DEVIATION REQUEST AND DECISION FORM

Project Name : Grandview Reserve Phase 1
Schedule No.(s) : 4200000396
Legal Description : TR OF LAND BEING A POR OF THE S2 OF SEC 21, S2 SEC 22, N2 OF SEC 28 & 27-12-64 DESC AS FOLS;COM AT SE COR OF SD SEC 21, TH N 00<52'26" W ON THE E LN OF SD SEC 2645.09 FT TO THE NE COR OF THE SE4 OF SD SEC 21 FOR POB, TH N 89<41'03" E ON THE N LN OF THE S2 OF SD SEC 22 3938.18 FT, S 00<41'58" E ON THE E LN OF THE W2 OF THE SE4 OF SEC 22 2117.66 FT TO A PT ON THE NWLY R/W LN OF THE ROCK ISLAND REGIONAL TRAIL, ALG SD NWLY R/W LN S 45<55'49" W 758.36 FT TO A PT ON THE S LN OF THE SE4 OF SD SEC 22, N 89<38'06" E ON SD S LN 36.18 FT, S 45<55'49" W 3818.92 FT TO A PT ON THE N LN OF THE SW4 OF SD SEC 27, S 89<39'01" W ON SD N LN 36.17 FT, S 45<55'49" W 855.35 FT TO A PT ON THE ELY LN OF SD SEC 28, N 00<21'45" W ON THE E LN OF THE SE4 OF SD SEC 28 591.16 FT TO THE NE COR OF SD SE4, N 00<21'38" W ON THE E LN OF THE NE4 OF SD SEC 28 1319.24 FT TO THE S LN OF THE N2N2 OF SD SEC 28, N 89<47'08" W ON THE S LN 4692.55 FT TO A PT ON THE ELY R/W LN OF EASTONVILLE RD, ALG SD ELY R/W ALG ARC OF CUR TO THE L HAVING A RAD OF 1630.00 FT AN ARC DIST OF 697.73 FT A C/A OF 24<31'32

Exhibit 2

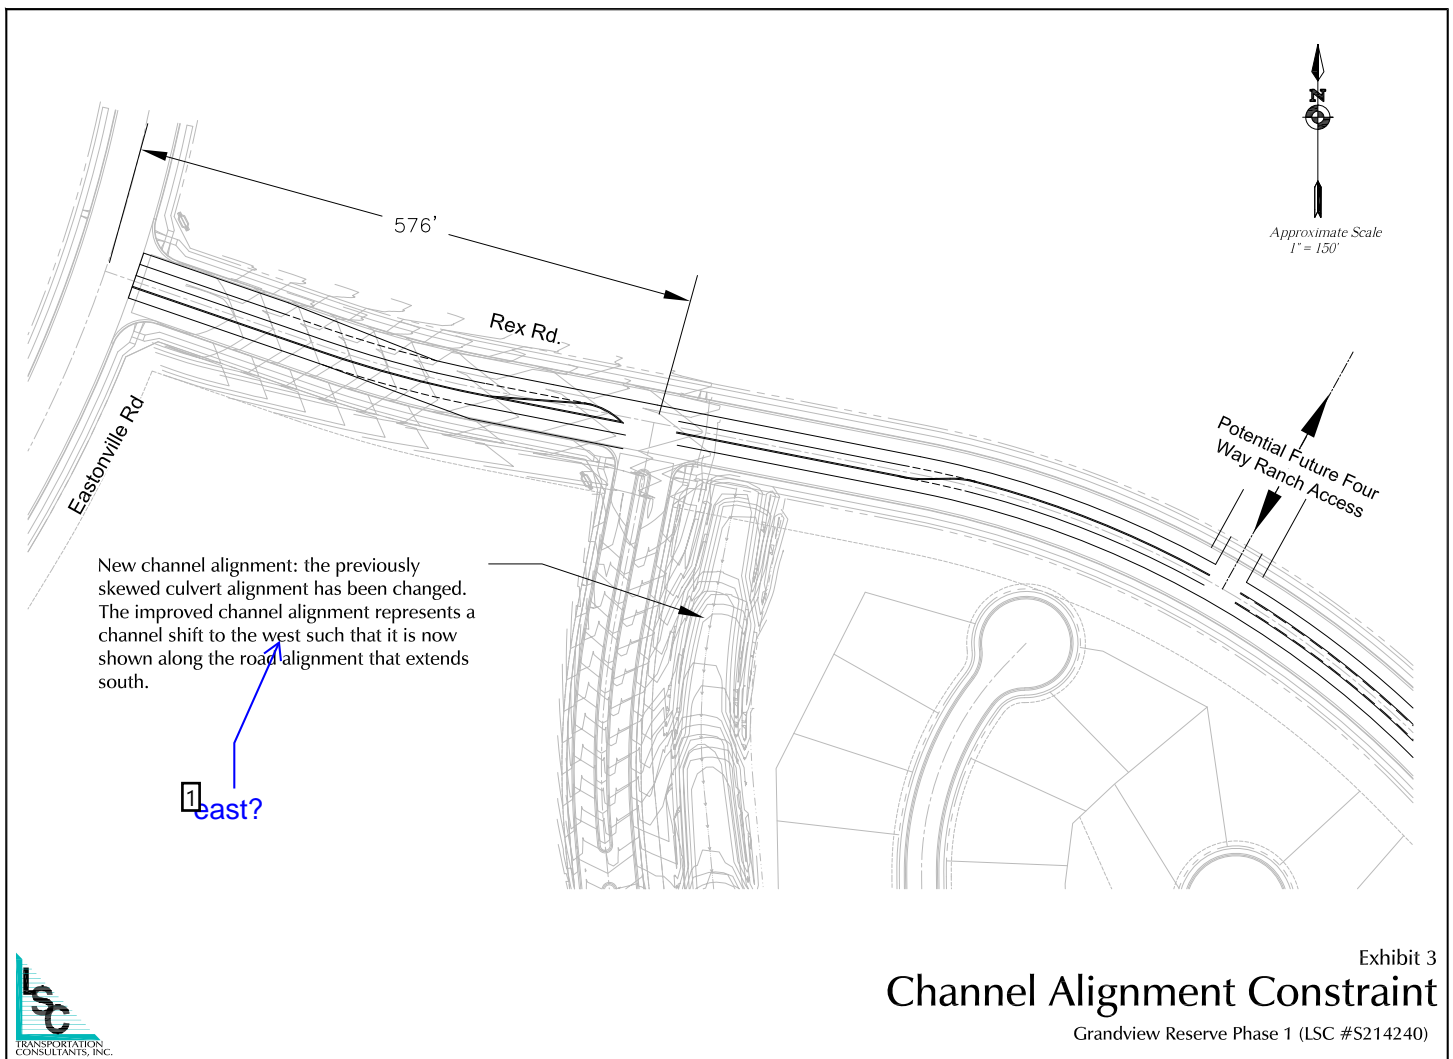
200' off

1 550' (minimum)
will be acceptable

Author: kdferrin Subject: Sticky Note Date: 12/10/2021 1:16:45 PM
LSC Response: Exhibit has been revised

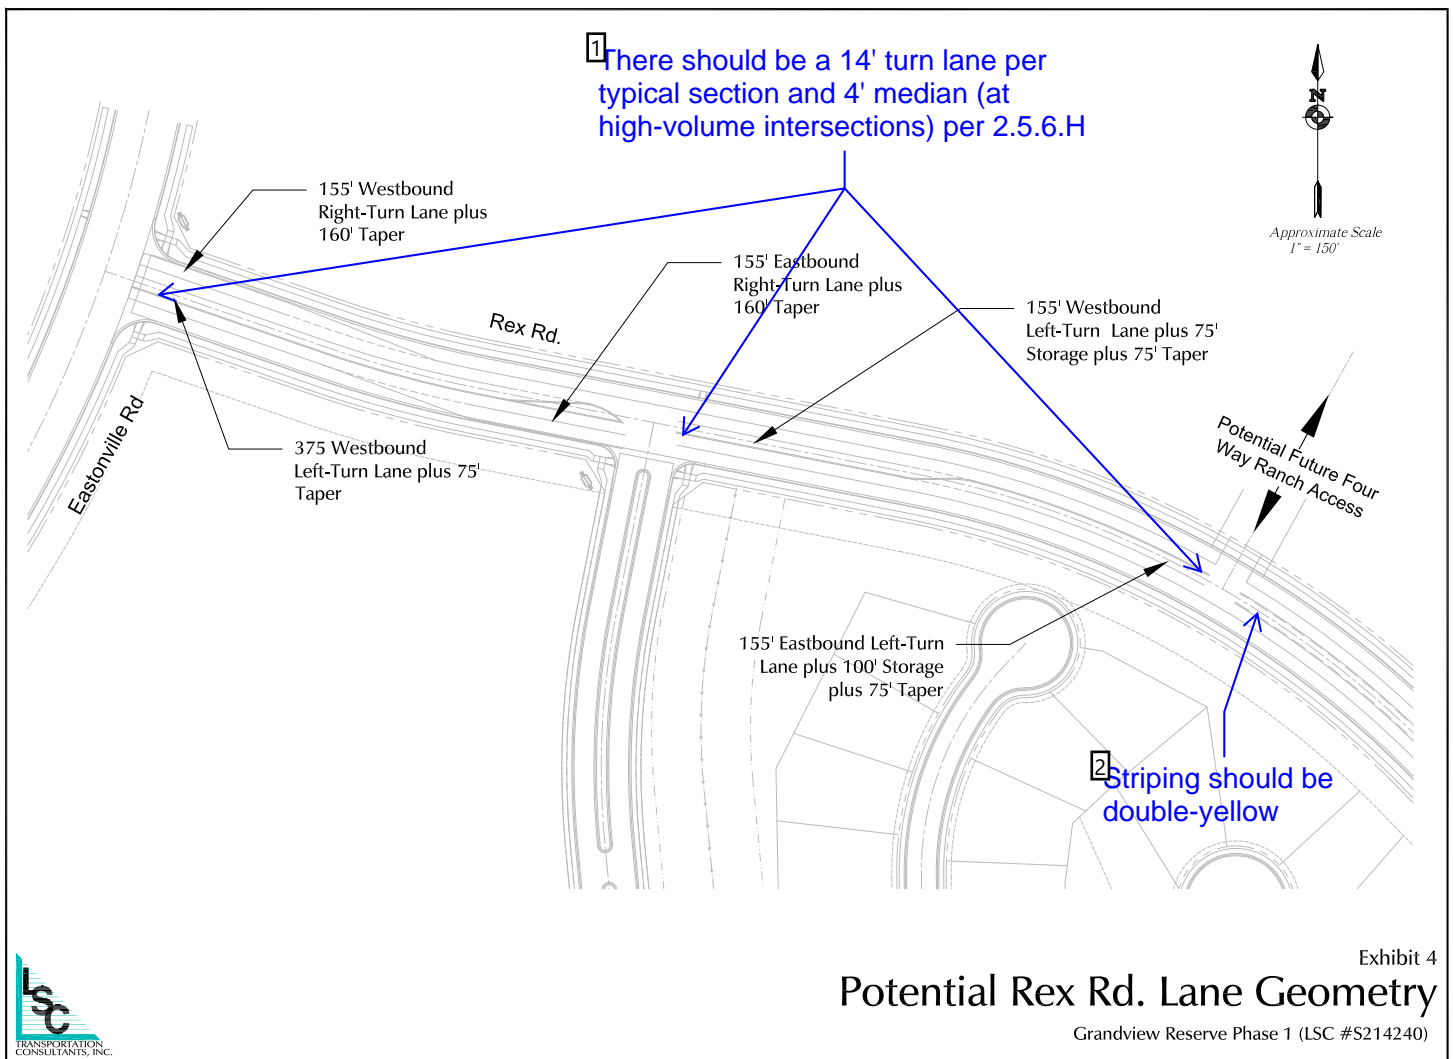
650' (minimum) will be acceptable

east?

Author: kdferrin Subject: Sticky Note Date: 12/10/2021 1:16:48 PM
LSC Response: Revised as requested

Author: kdferrin Subject: Sticky Note Date: 12/10/2021 1:16:58 PM
LSC Response: Exhibit has been revised

There should be a 14' turn lane per typical section and 4' median (at high-volume intersections) per 2.5.6.H

Striping should be double-yellow

Author: kdferrin Subject: Sticky Note Date: 12/10/2021 1:17:48 PM
LSC Response: A note has been added to the exhibit indicating the required cross section

Author: kdferrin Subject: Sticky Note Date: 12/10/2021 1:17:59 PM
LSC Response: The exhibit has been revised as requested
